# Issue 9

## Proposal: Allow Interconnecting DER to Be Evaluated and Operate Under Limited Generation Profile

**Summary:** Modify interconnection procedures to allow a DER customer to submit a “Limited Generation Profile” as part of their Interconnection Application, require that customer to enable generation profile limiting functionality, and allow utility limited future opportunity to alter that profile if circumstances warrant.

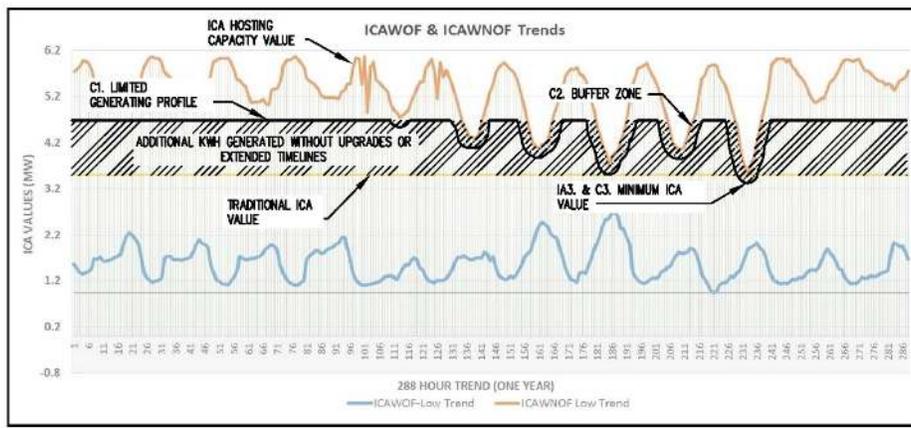
**Commented [Cal PA1]:** Based on the Public Advocates Office’s assessment, the Issue 9 proposal fits squarely within the ICA uses cases identified in the ICA Working Group’s Final Report; it makes the interconnection process less costly and allows for more sophisticated, potentially less expensive distribution planning on the part of the IOUs. It has the potential to avoid certain rate-based distribution upgrades. The Public Advocates Office supports the proposal while recognizing that there are numerous challenges facing its implementation.

Below are suggestions the Public Advocates Office would like to advocate for to address such challenges in future Working Group meetings.

- 1. Incorporate the findings of the Smart Inverter Working Group.** The IOUs have stated that grid operators would need real-time data from and potentially control over DERs for this proposal to be implemented. The Smart Inverter Working Group (SWIG), part of Rulemaking (R.) 14-08-013, has defined protocols to communicate with smart inverters, along with monitoring and control functions that should be able to support the Issue 9 proposal. The Working Group should comprehensively review the reports, decisions and resolutions issued to date and work with Energy Division and to ensure that any research and analysis is not duplicated in this working group unnecessarily.

- 2. Encourage IOUs to develop verification processes for generator profiles.** This proposal hinges on the ability of the IOUs to verify and have operational confidence in the generation profiles submitted by DERs. The Public Advocates Office recognizes that IOUs will be, at times, forced to rely on these profiles when ensuring safety and reliability. Any verification processes would need to be developed by IOUs to be effective. The Public Advocates Office encourages the IOUs to engage with the proposal and develop a draft generation profile verification process that would give them confidence implementing the proposal.
